IREDELL COUNTY HEALTH DEPARTMENT

IMPROVEMENT PERMIT / AUTHORIZATION TO CONSTRUCT / OPERATION PERMIT / EXISTING SYSTEM INSPECTION

PERMIT# 094920 PIN# ~~4625~~ 94 1684 (pt) 4625-73-2299 DATE June 13, 01

SUBDIVISION The Point BLOCK / SECTION 7 LOT 702/702A LOT AREA 30587 + 18794 ft² SITE CLASS. PSSFE DESIGN FLOW 480 gpd L.T.A.R. .3

AS BUILT SKETCH

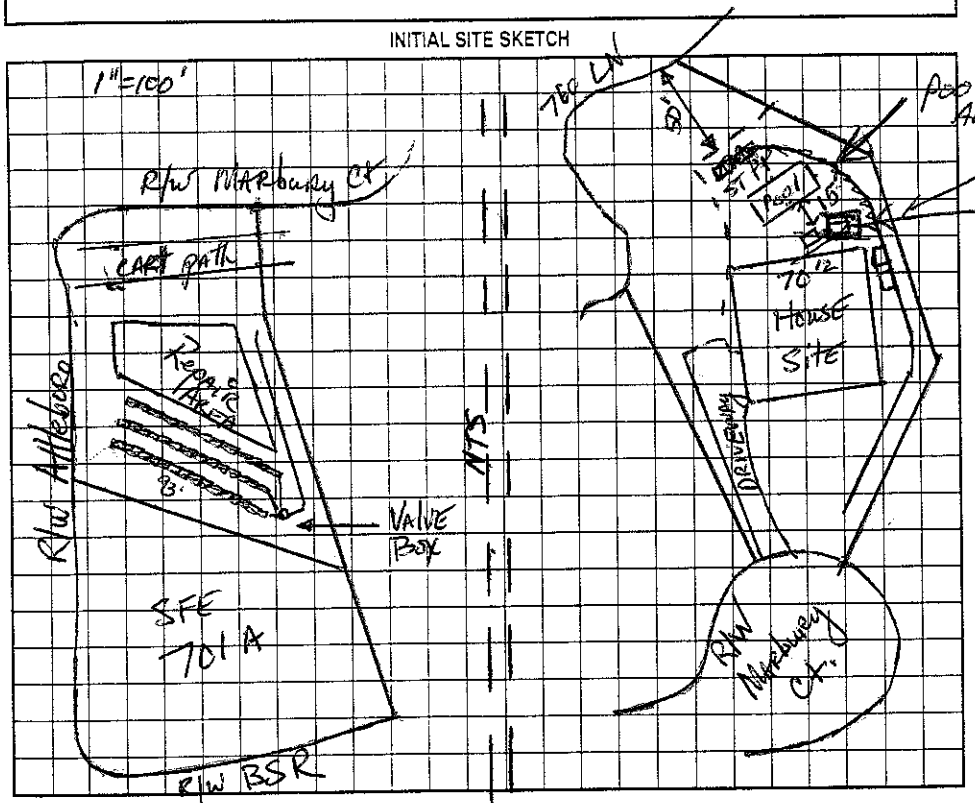
Pool Added

Tank Location changed

Outdoor Kitchen (No Plumbing)

The proposed / existing Outdoor Kitchen addition does not appear to impact the existing septic system.

**NOTE: Must be at least 5FT From Septic Tanks

* Owner says No plumbing in Outdoor kitchen
